SERVICE BULLETIN

SB1237

VEHICLE MODEL: T2145, C2045

SUBJECT : Caterpillar maintenance schedule updates

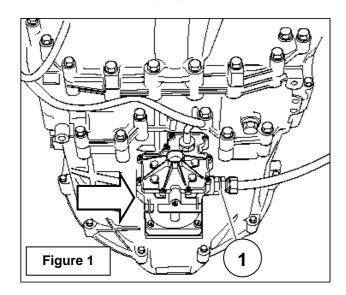
By means of the drain valve, bleed the air pressure from the "Astronic" auxiliaries tank supplying the clutch servo (for location of the air tanks, refer to the Maintenance Manual). Locate the clutch servo (Figure 1).

Disconnect the air supply line from the clutch servo (1, Figure 1).
